KAWARTHA PINE RIDGE DISTRICT SCHOOL BOARD
PUR24-100-ITT
Murray Centennial Public School Addition

ADDENDUM NO. 3

Add (1): Architectural Addendum No. 2, Prepared by Moffet and Duncan Architects Inc. (34 Pages)

INTERIOR PHASING PLAN & RCP

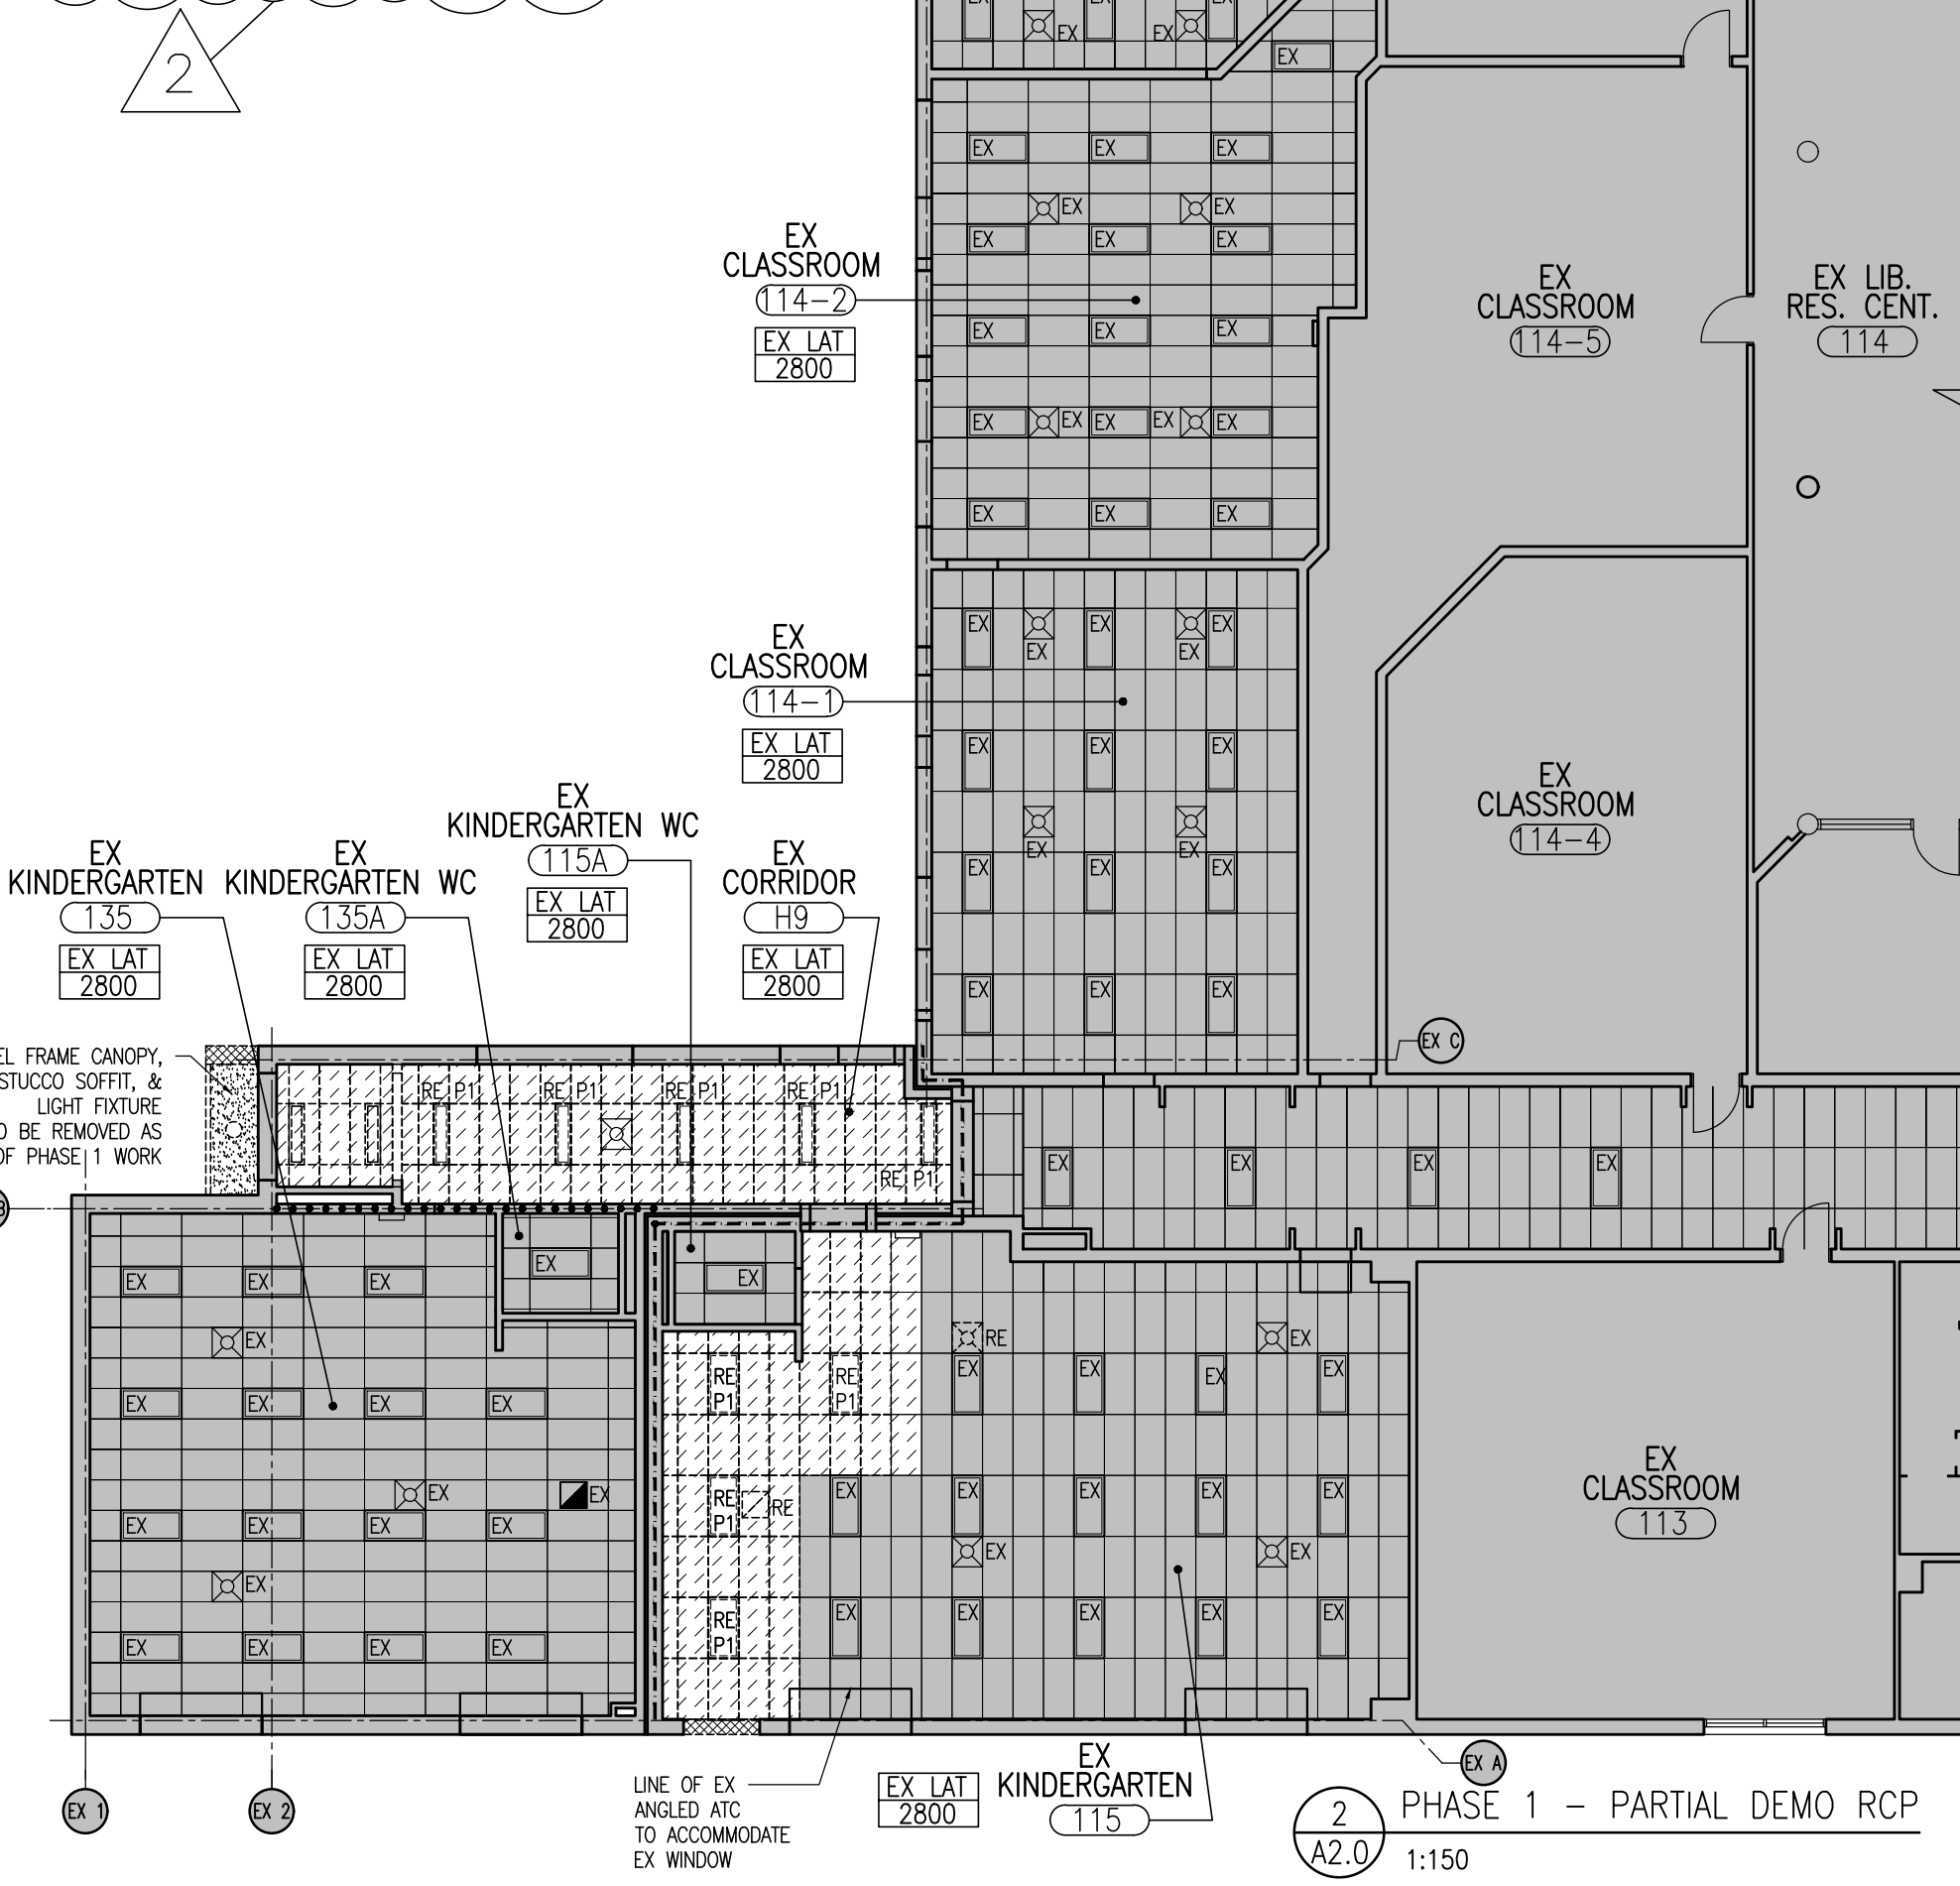
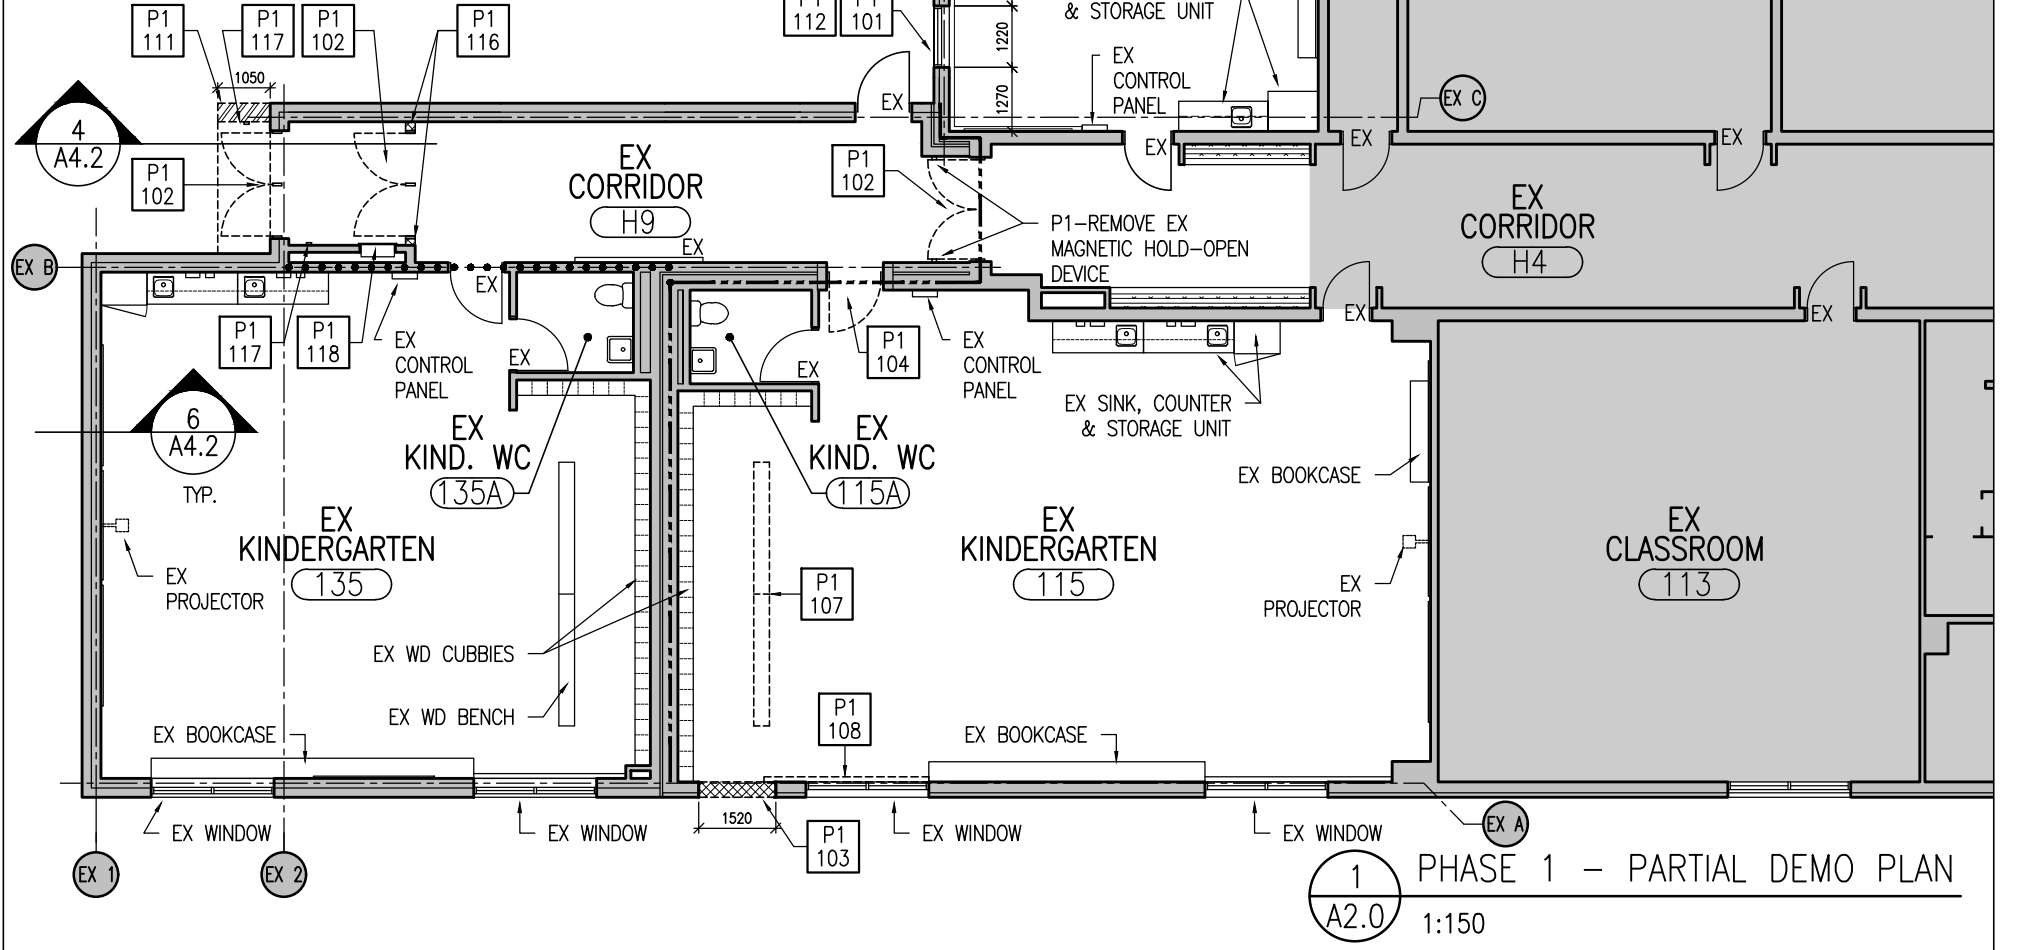
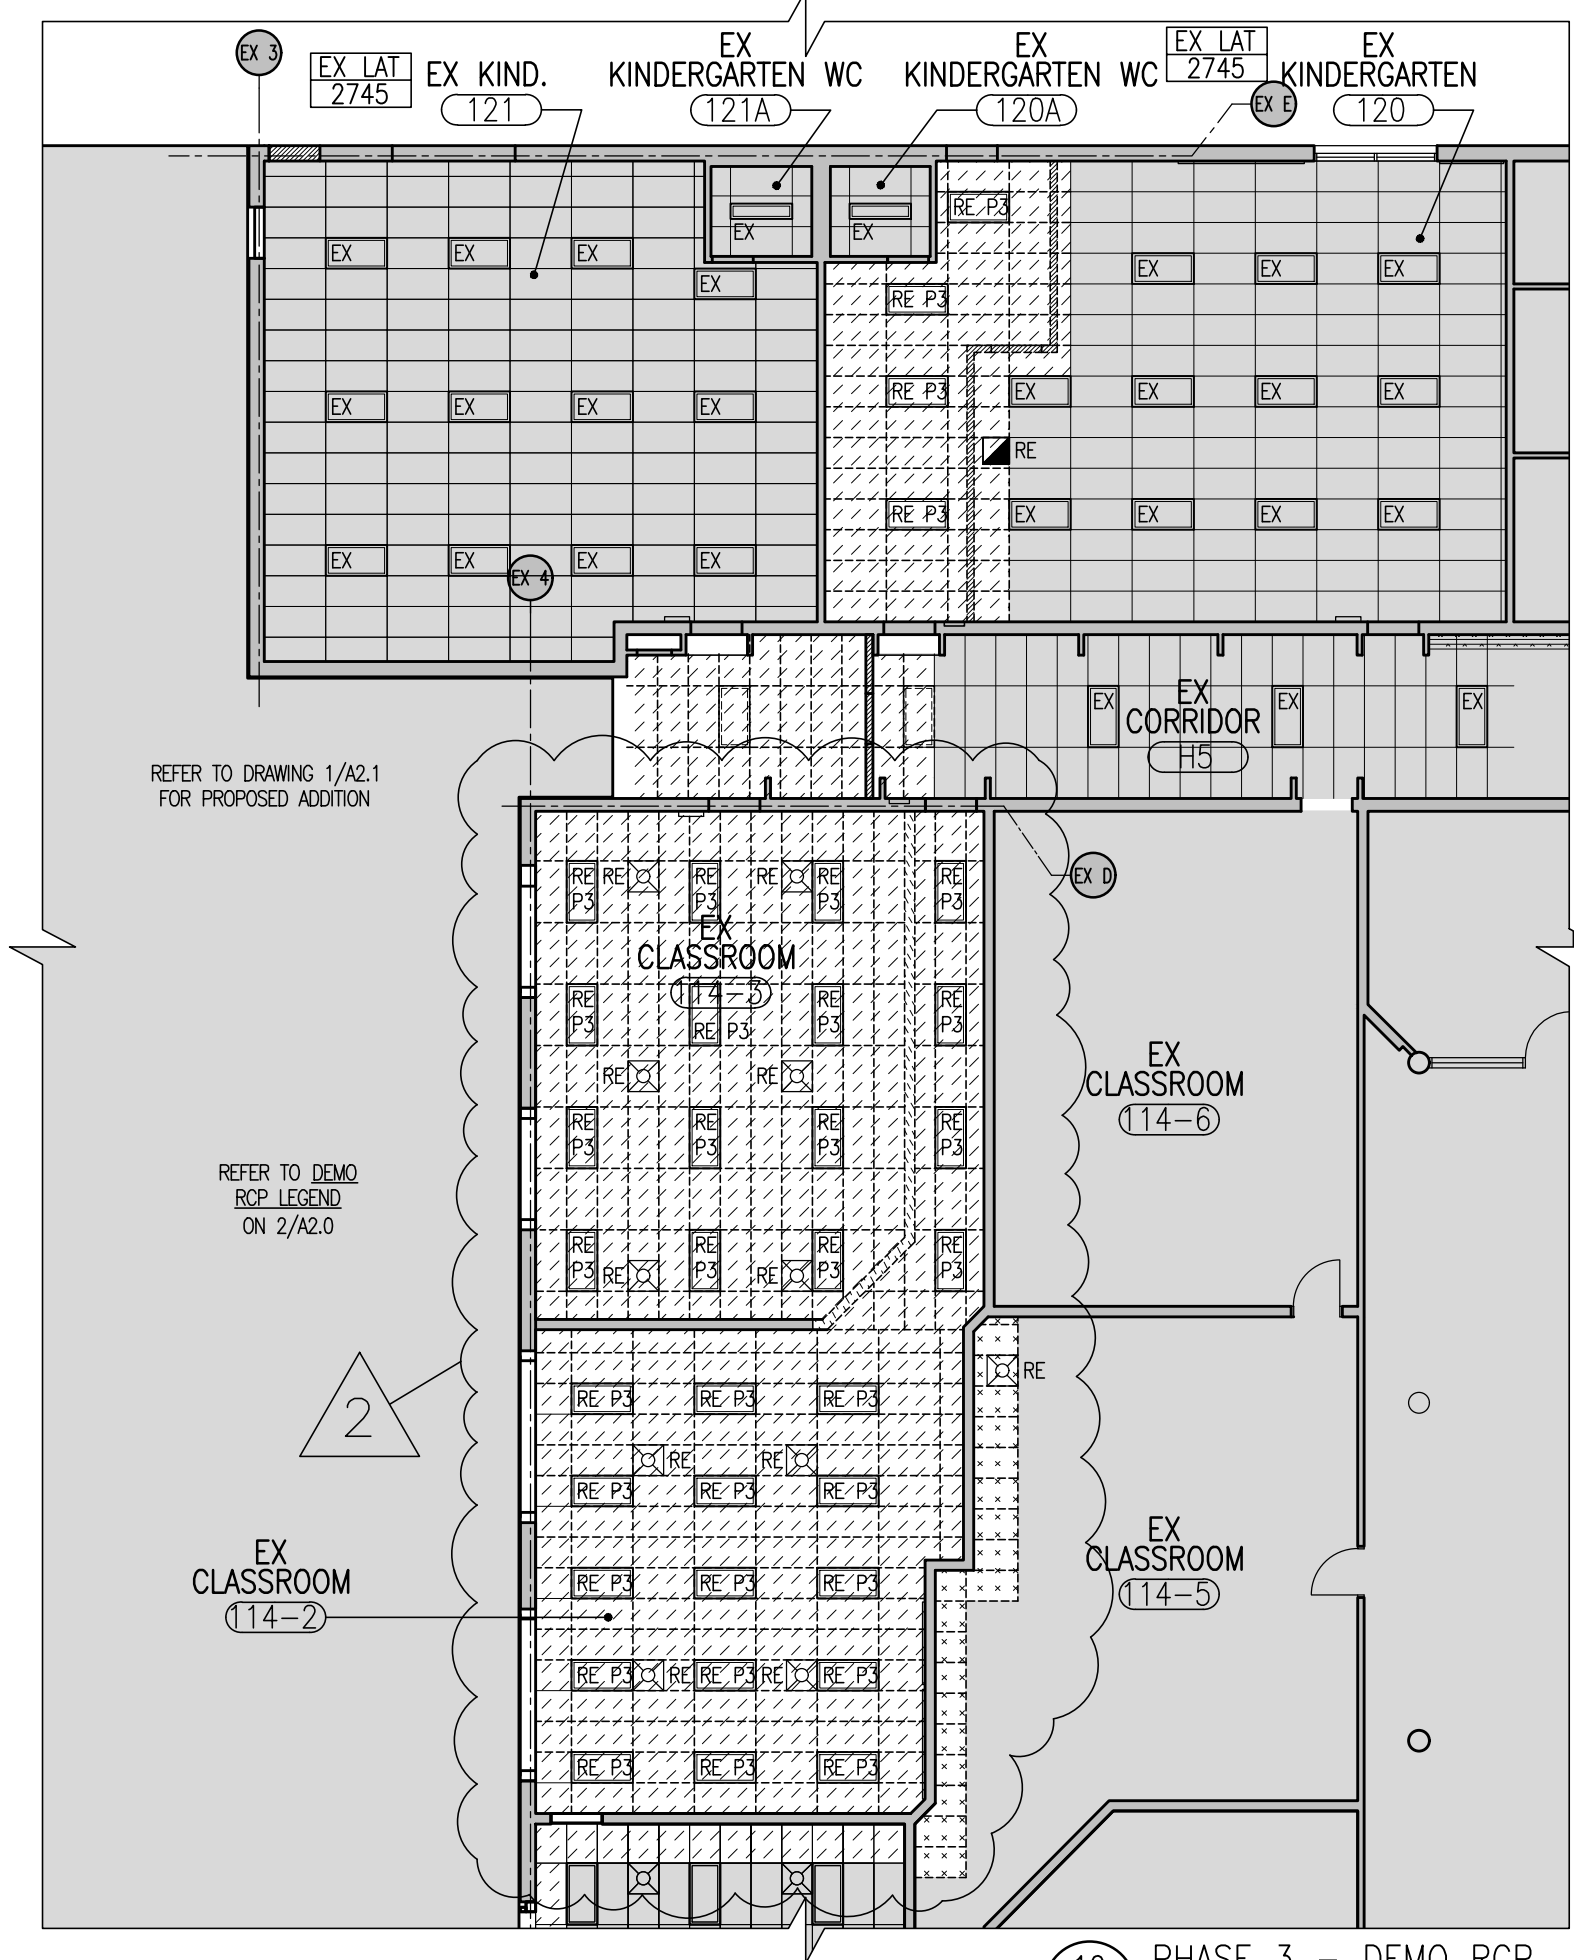
- .1 Replace Drawing A2.0 with enclosed Drawing A2.0 Addendum 2.
- .2 Refer to "DEMO RCP LEGEND" on Dwg 2/A2.0 for additional note "DENOTES AREA OF EX FIRE RATED ACOUSTIC CEILING TILE & TBAR GRID TO BE REMOVED & REINSTATED"
- .3 Refer to Dwg 9 & 10/A2.0 for additional area of ex ATC and lighting removal and reinstallation.
